TECHNICAL BULLETIN

K430NAS1

Service Action: Roof Opening Panel Air Deflector Springs Displaced

F-PACE (X761)

E193537

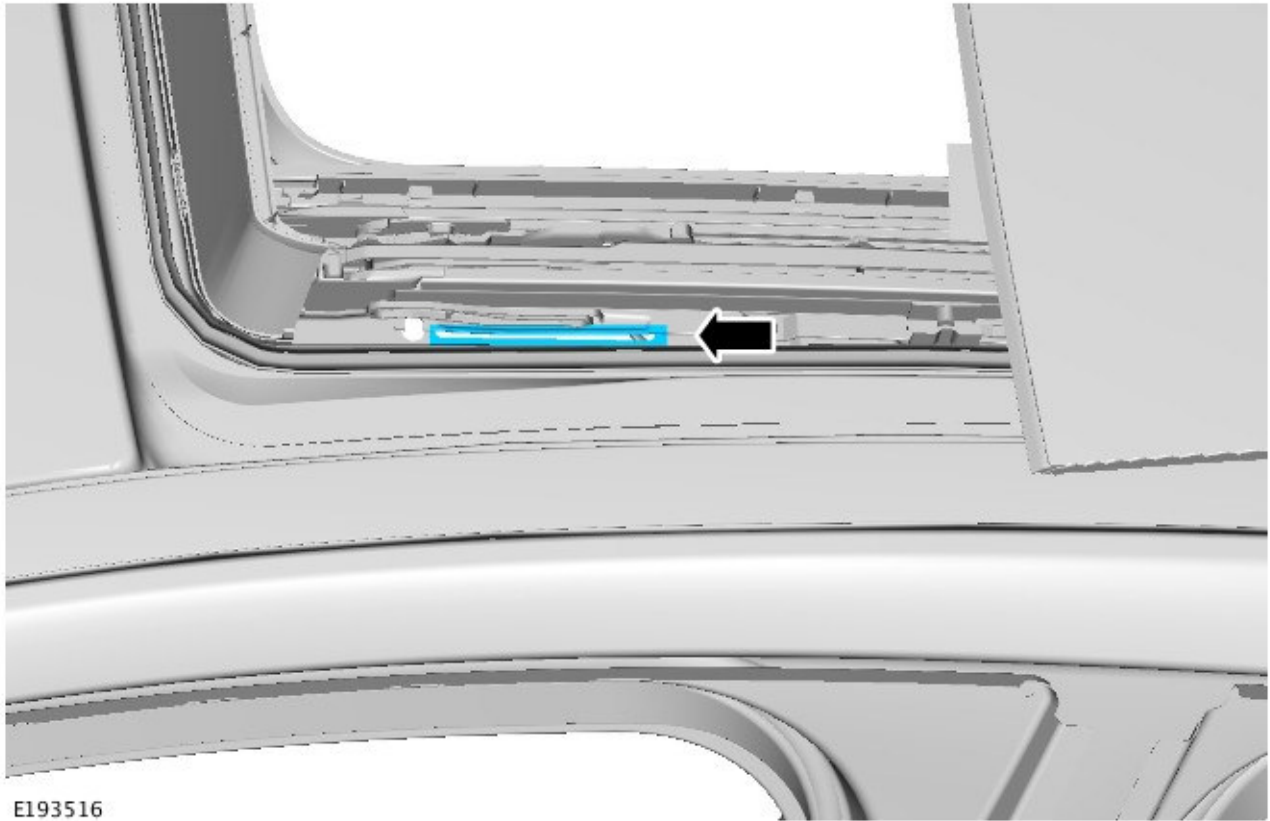
1. Switch the ignition ON (engine not running).
2. Open the roof opening panel to its fully open position.
3. Switch the ignition OFF.
4.  **NOTE: Left-side shown; right-side similar.**

**NOTE: Parts shown removed for clarity.**

Locate the area shown.

5. Cut and discard 20 mm from the rubber seal.

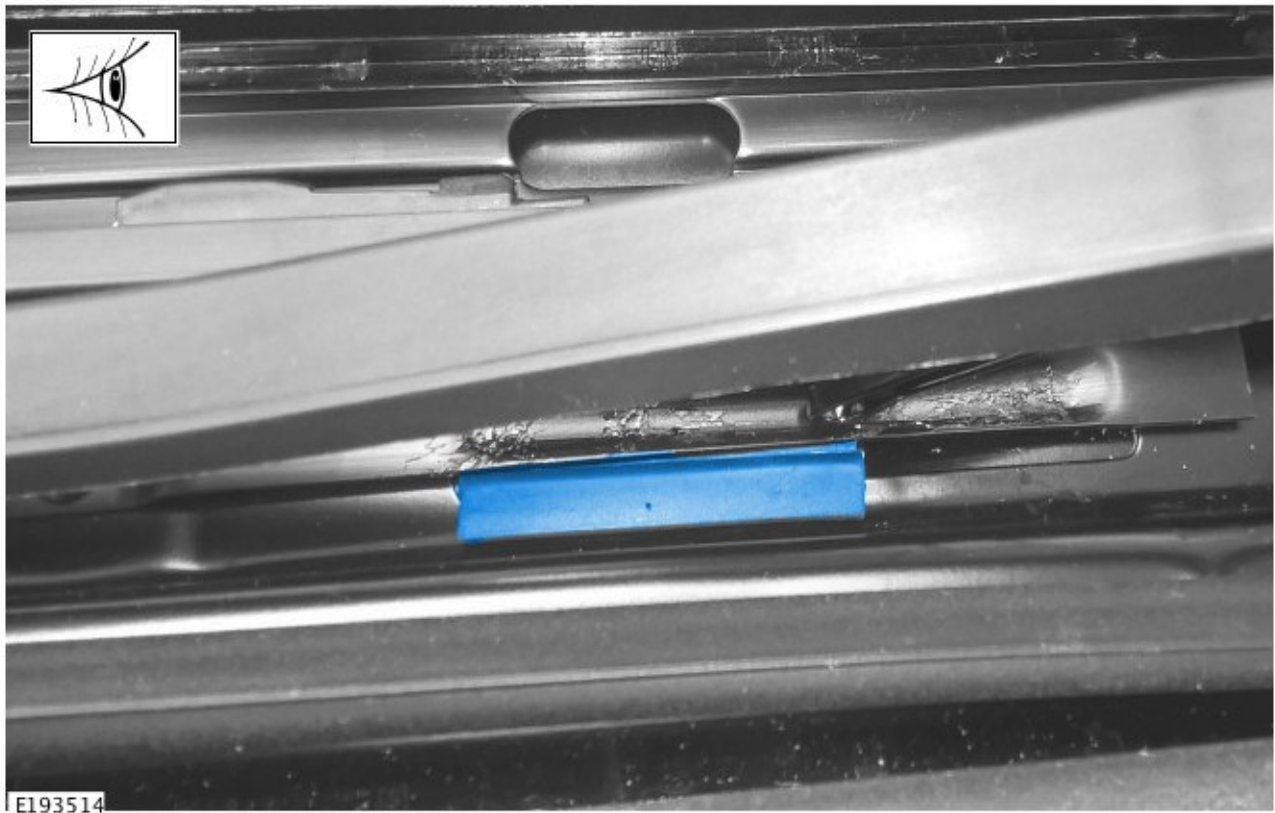
6.  **NOTE: Right-side shown; left-side similar.**

**NOTE: Seal length: 60 mm.**

Install the rubber seal
